Consideration of Burstiness in Bridged Fronthual Network

Tongtong Wang, Huawei

Figure B-1—Self-queuing

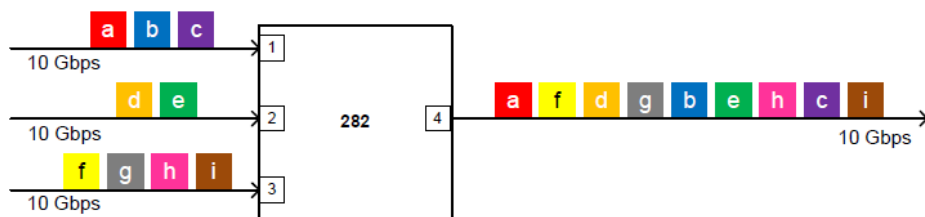
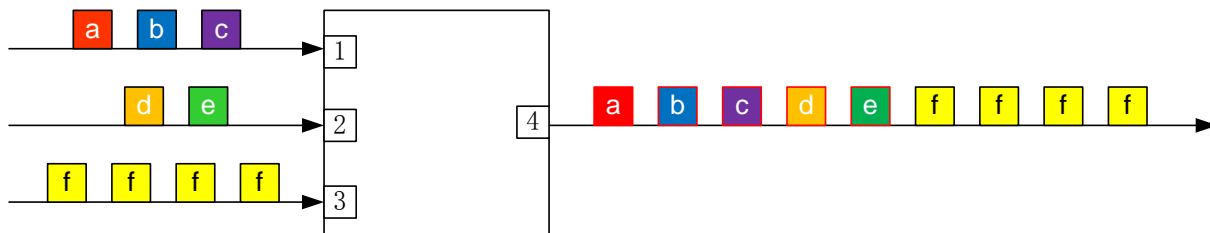
First example is from D0.5 Annex B, each CPRI flow has one packet coming in this scheduling cycle.

In second example, if CPRI IQ data flow *f* has 4 packets coming in burst and a credit based scheduler can arrange the output like this, assuming each port has enough credit to go. The latency of packet “a” is not only related to number of CPRI IQ data flows, but also burstiness of each flow.

This is the impact of burstiness on bridge latency.

- Keep Eq 7-1 as is.
- Propose to change equation 7-2 to

$$t_{self-queuing} = \sum_{i=1}^{N-1} \sum_{j=1}^{F_i} (B_j * t_{MAXIQFramSize + Pre + SFD + IPG})$$
